Response to Action Item 5-6 Section 5.4.2.2

MEB Issue List Regarding APR-1400, FSAR Section 5.4.2.2

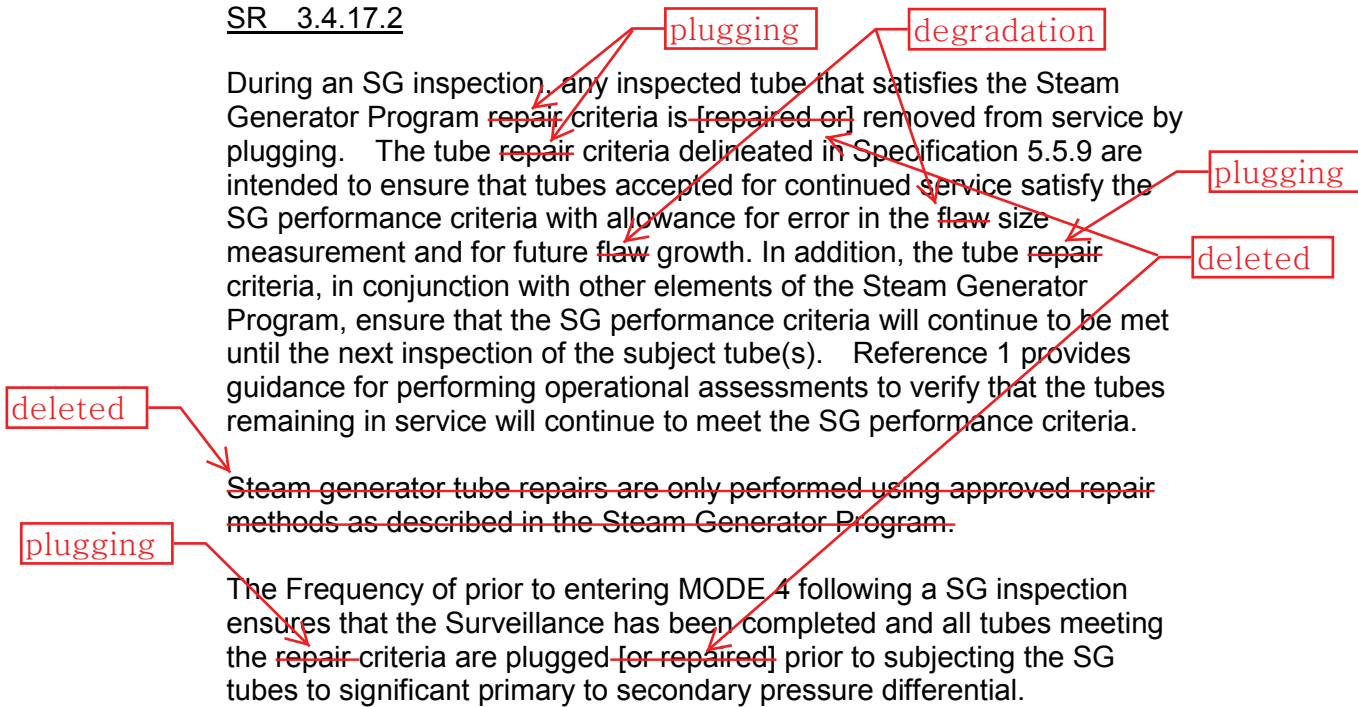
- Since the APR 1400 design certification is not requesting approval of tube repair methods (e.g., sleeving), delete the three references to tube repairs from the TS Bases Section SR 3.4.17.2. The three references are, “[repaired or], [or repaired], and the sentence, “Steam generator tube repairs are only performed using approved repair methods as described in the Steam Generator Program.”

KHNP will delete the three references from the TS Bases Section SR 3.4.17.2 as shown in Attachment 9.

~~Steam generator tube repairs are only performed using approved repair methods as described in the Steam Generator Program.~~
